BID ADDENDUM NO. 3

CONSTRUCTION NEW GEORGE WYTHE HIGH SCHOOL (RHSA)

**IFB # 23 – 7061 – 11
RRMM Project # 21310 – 00**

**January 4, 2024
Architect of Record:
RRMM, Architects, PC
1317 Executive Boulevard
Suite 200
Chesapeake, VA 23320
Phone: 757-213-6350**

FIRST FLOOR PLAN - AREA 'A' - POWER

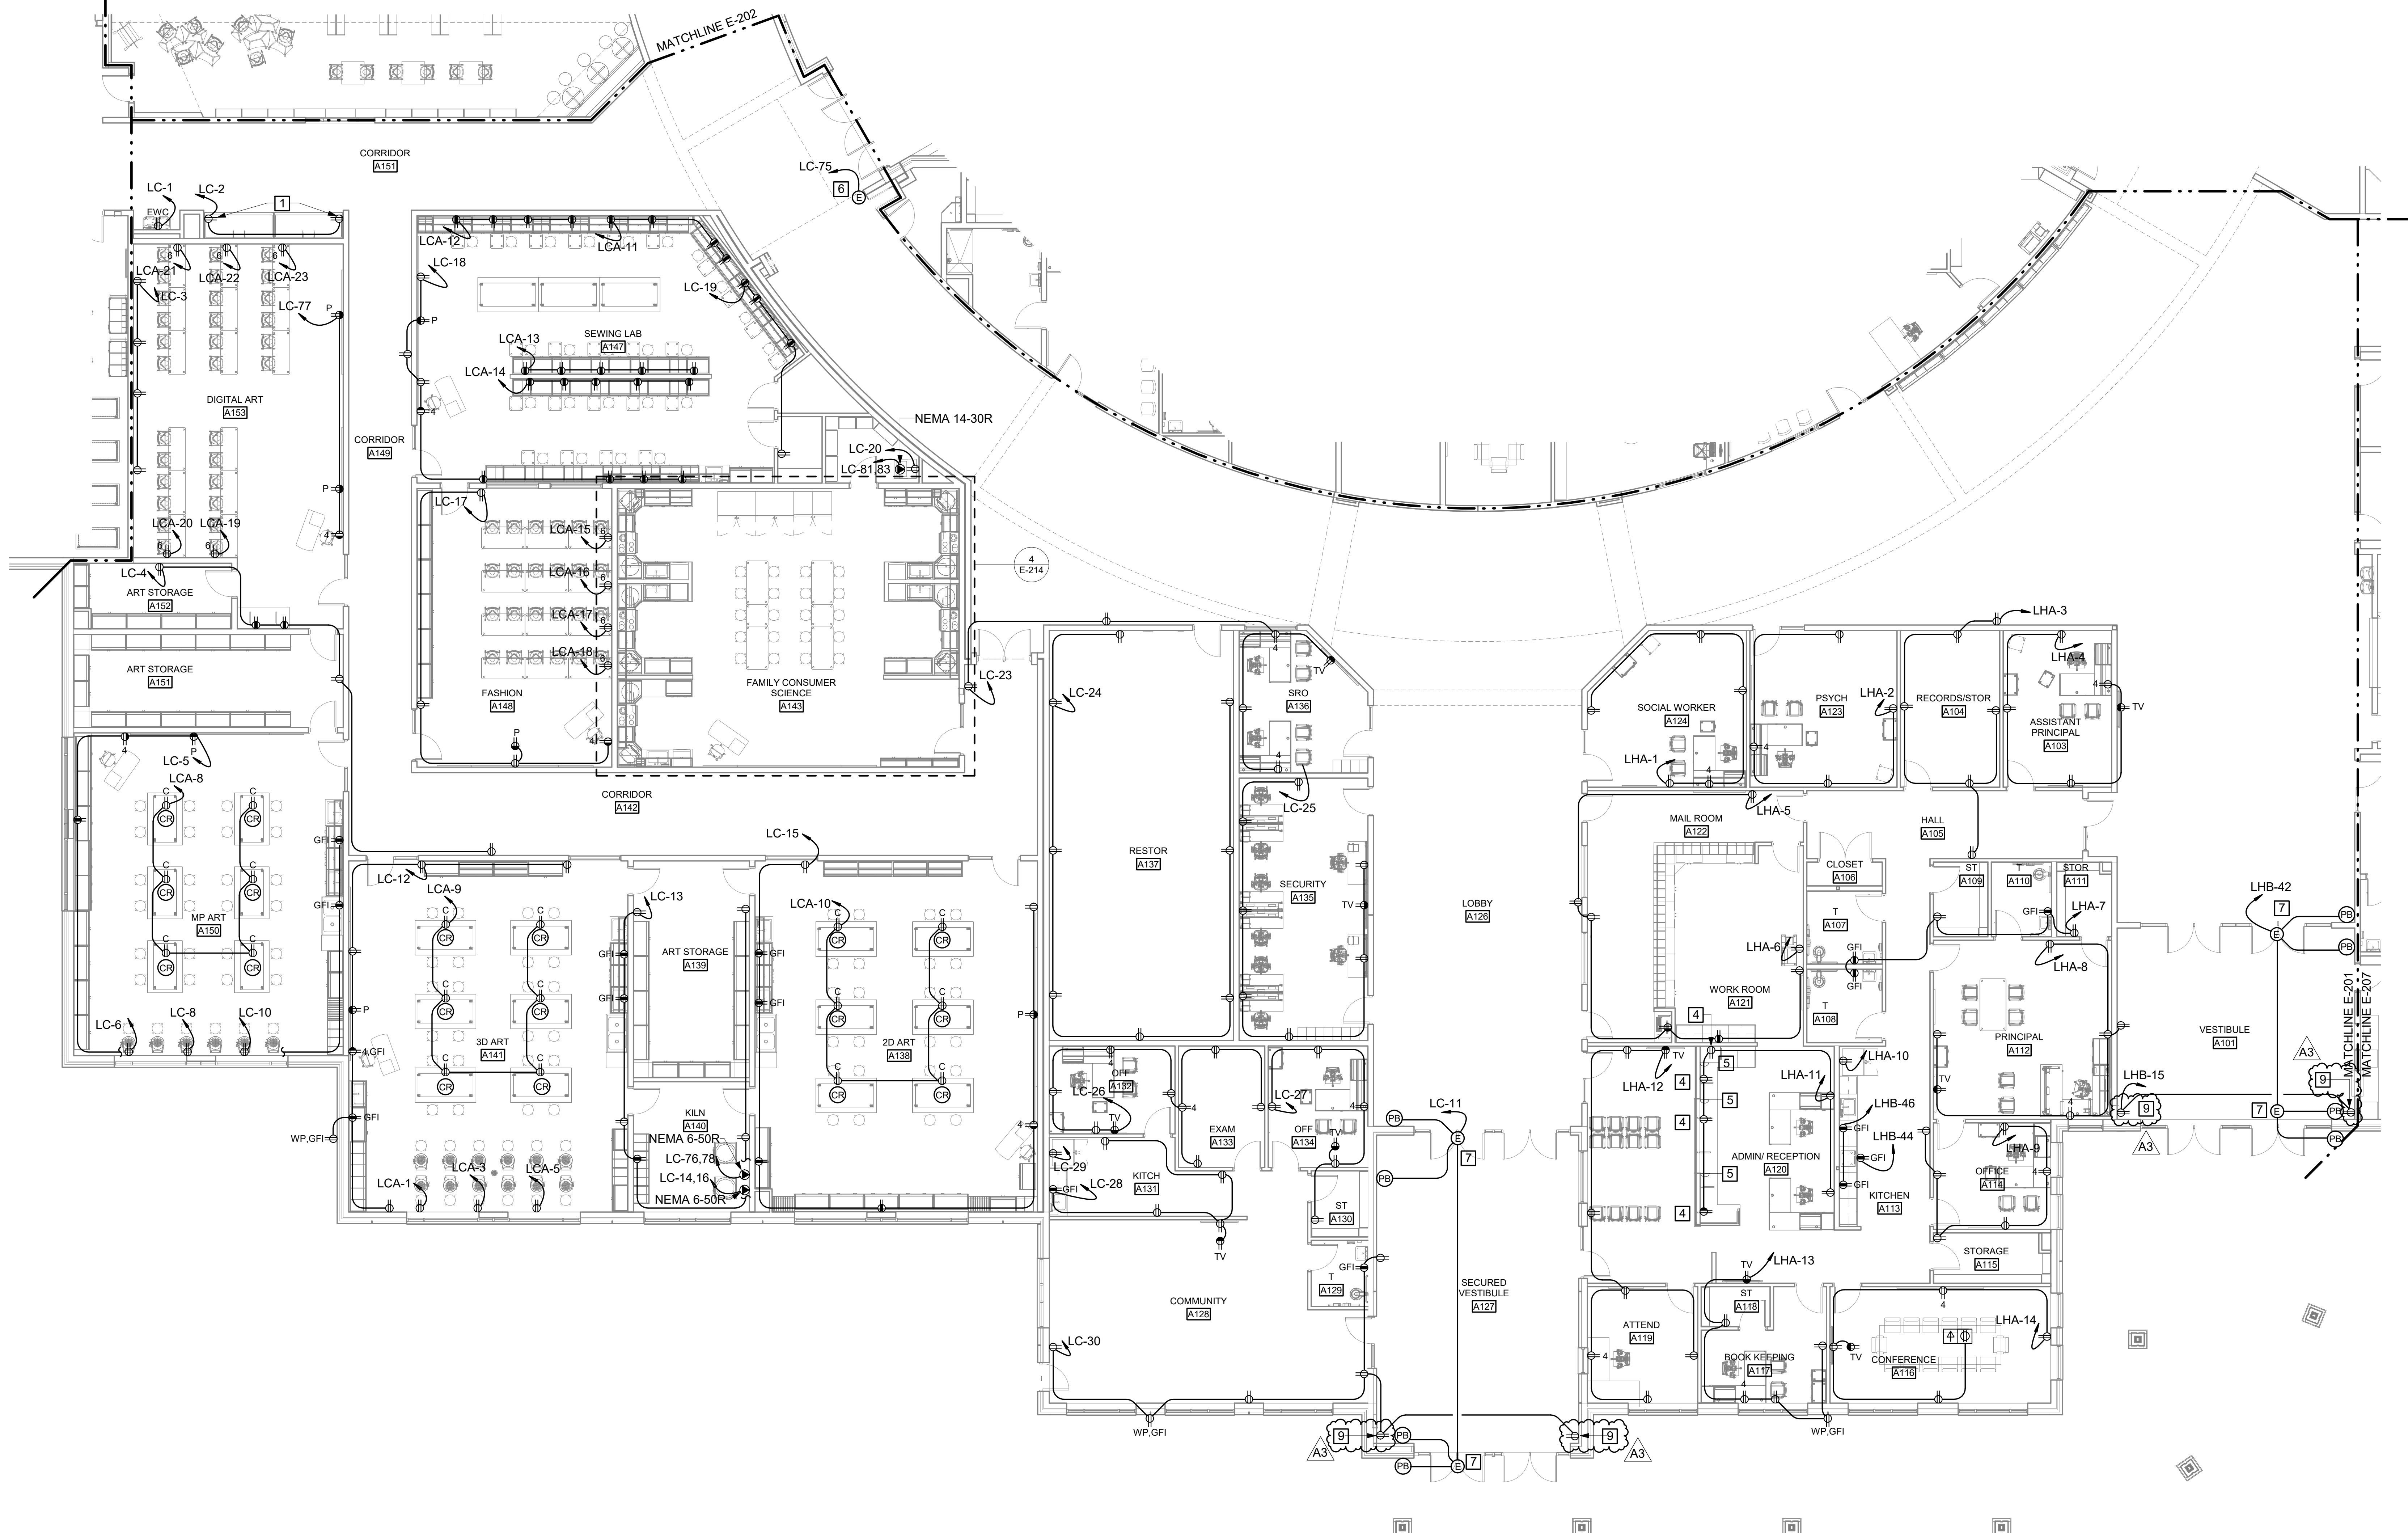
- 3.18 SHEET A-613 - STOREFRONT ELEVATIONS: **REVISE** all instances on sheet referring to Roller Shade “RS1” to be Roller Shade “**RS2**”.
- 3.19 SHEET E-201 - FIRST FLOOR PLAN – AREA ‘A’ – POWER:

- First Floor Plan – Area ‘A’ – Power – **ADD** keynote 9 to vestibules A101 and A127 per the attached revised sheet.
 - Construction Notes – **ADD** Keynote 9 per the attached revised sheet.

PROJECT: RICHMOND PUBLIC SCHOOLS
PROJECT: GEORGE WYTHE HIGH SCHOOL
DRAWING: FIRST FLOOR PLAN - AREA 'C' - POWER

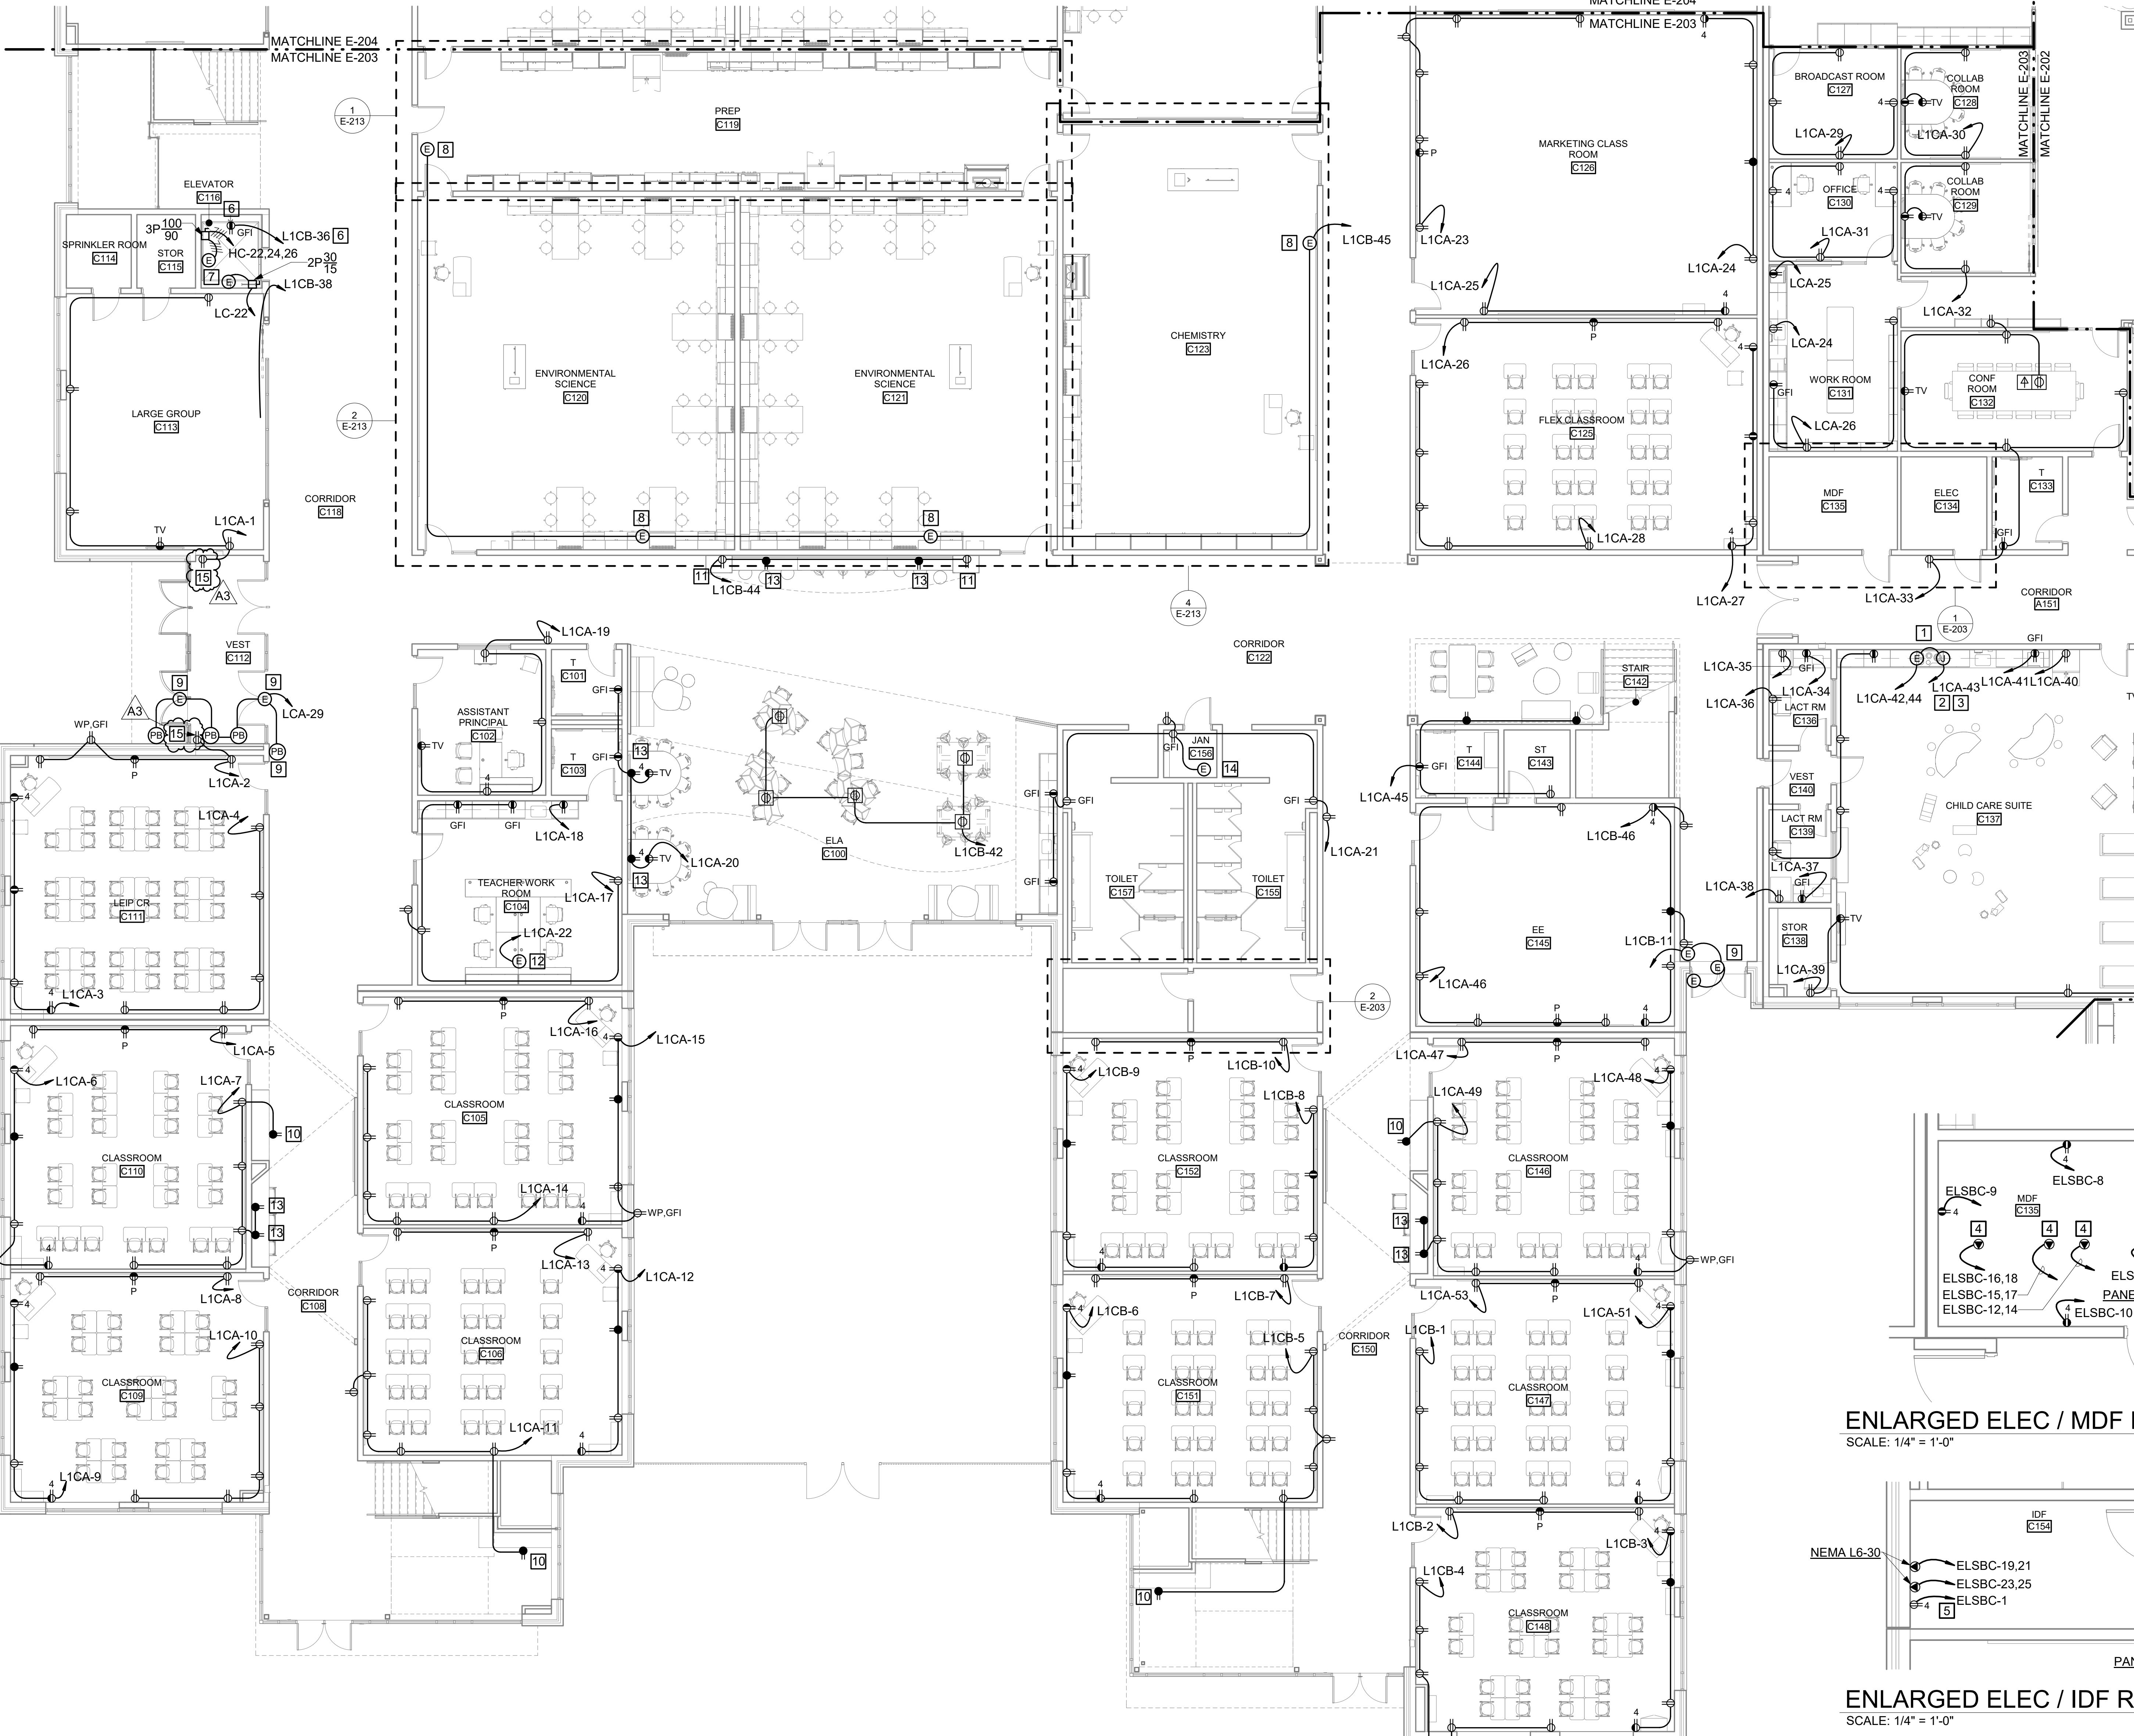
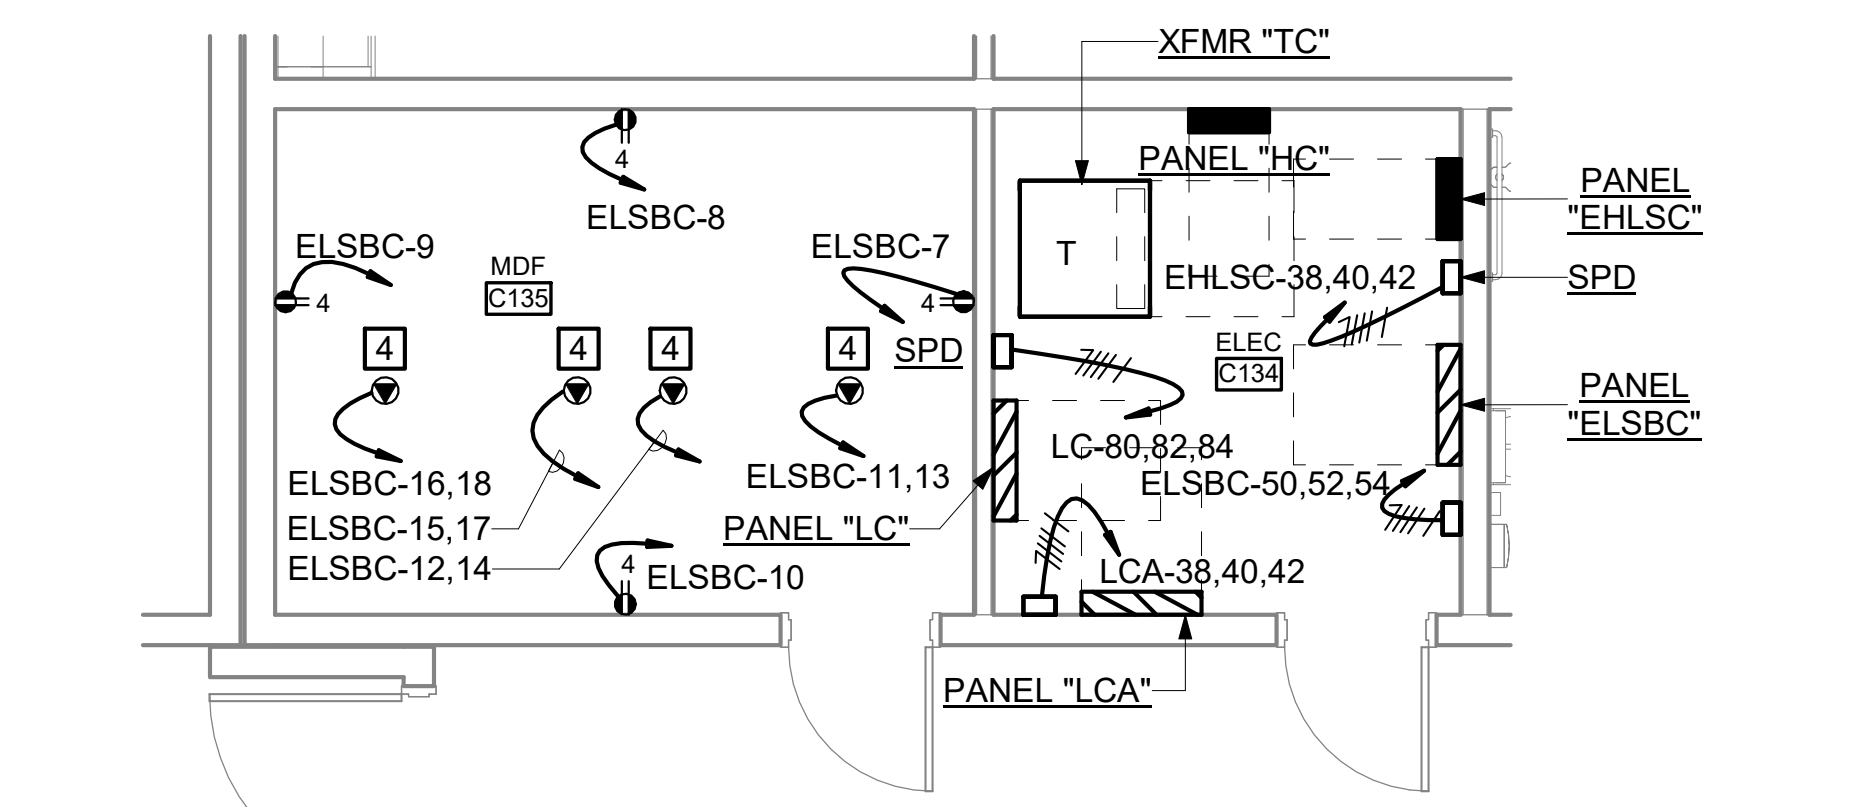
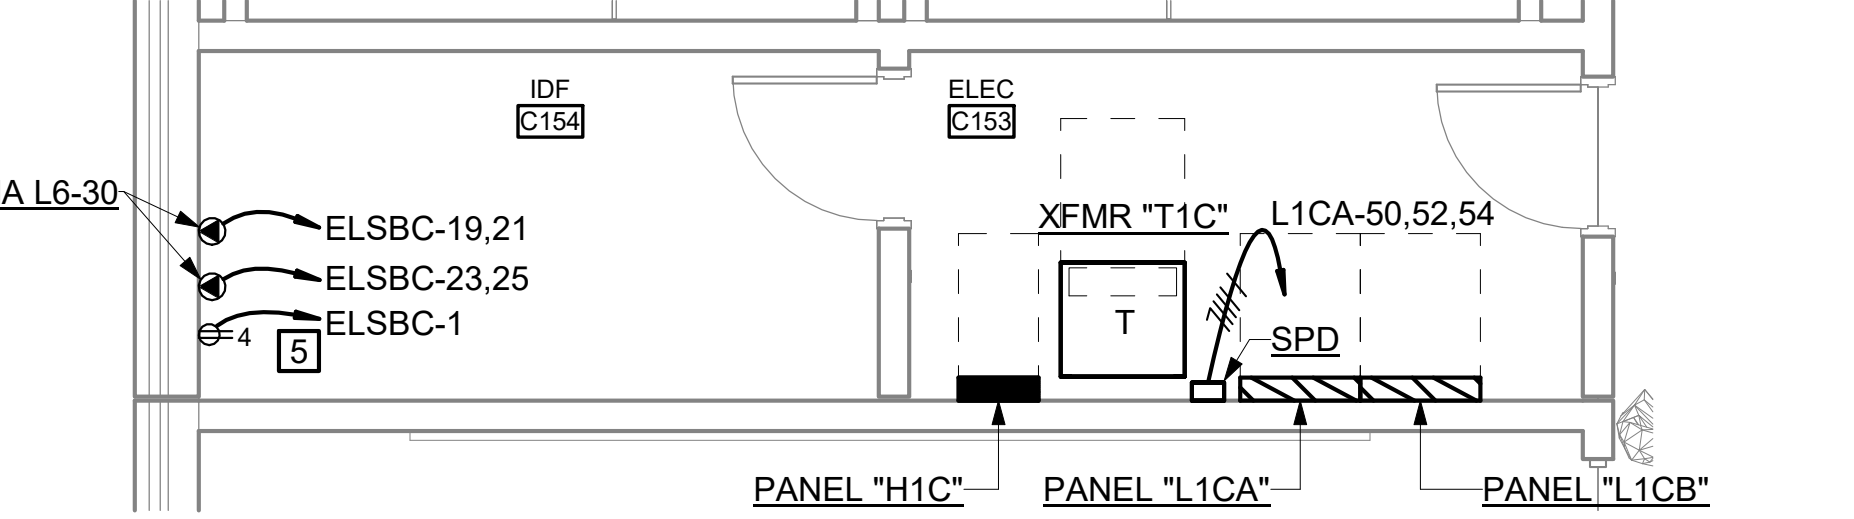
- 3.20 SHEET E-203 - FIRST FLOOR PLAN – AREA ‘C’ – POWER:
- First Floor Plan – Area ‘C’ – Power – **ADD** keynote 15 to vestibules C112 per the attached revised sheet.

- Construction Notes – **ADD** Keynote 15 per the attached revised sheet.
- 3.21 SHEET E-204 - FIRST FLOOR PLAN – AREA ‘D’ – POWER:
- First Floor Plan – Area ‘D’ – Power – **ADD** keynote 7 to vestibules D128 per the attached revised sheet.
